CLARIFICATION NO.1

**CONSTRUCTION OF LACLO-SUMASE IRRIGATION SCHEME
MANATUTO MUNICIPALITY (TENDER/174/MAPPF-2025)**

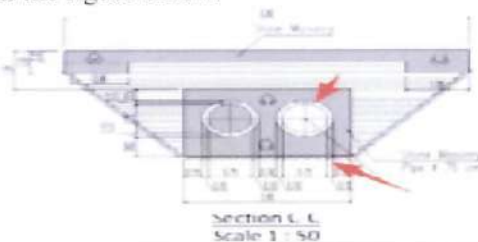
16.	<i>Drg. No: 1-04-01-230:</i> Please provide the detailed drawing of the structure indicated by the arrow in the figure below. 	That is the pipe accessories (fabricans), the price included in the siphon pipe price.

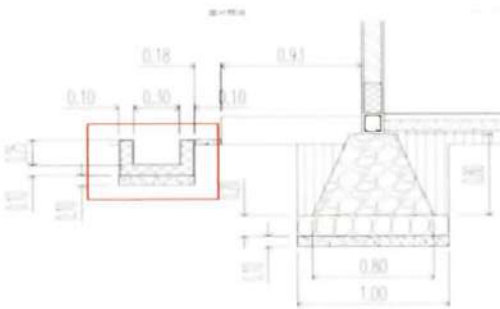
No.	Questions	Responses
18.	<i>Drg. No:1-04-01-230:</i> Please provide the structural details of the 10cm-thick component encircling the siphon pipe as indicated by the arrow in the figure below. 	That is the pipe thickness (specification material of pipe), not a another structure.

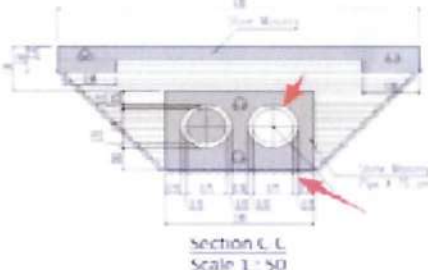
16.	<i>Dezenho. No: 1-04-01-230:</i> Favor fornese dezeńu detallu kona-ba estrutura ne'ebé indika hosi flecha iha figura iha kraik. 	Ne'e maka asesóriu kanu nian (fabricans), nia folin inklui ona iha folin kanu sifón nian.

18.	<i>Dezenho. No:1-04-01-230:</i> Favor fornese detalhe estrutural sira hosi componente ho mahar 10cm ne'ebé hale'u kanu sifón nian hanesan indika hosi flecha iha figura iha kraik.	Ne'e maka kanu nia mahar (materiál espesifikasaun kanu nian), la'ós estrutura seluk.

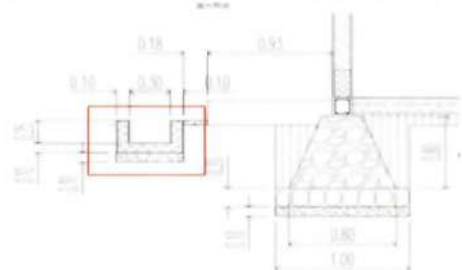
21.	UNPRICED BOQ_TENDER-2025 Konstrusaun ba Fasilidade Edifisiu Remata Ranhura simentu husi parede tijolu mean: Konkorente interpreta ida-ne'e hanesan refere ba área ne'ebé indika iha caixa mean iha figura iha kraik. Favor klarifika área superfisie ne'ebé maka dezeńu ida-ne'e refere ba. 	Ida-ne'e area drenajen ba uma guarda nian.
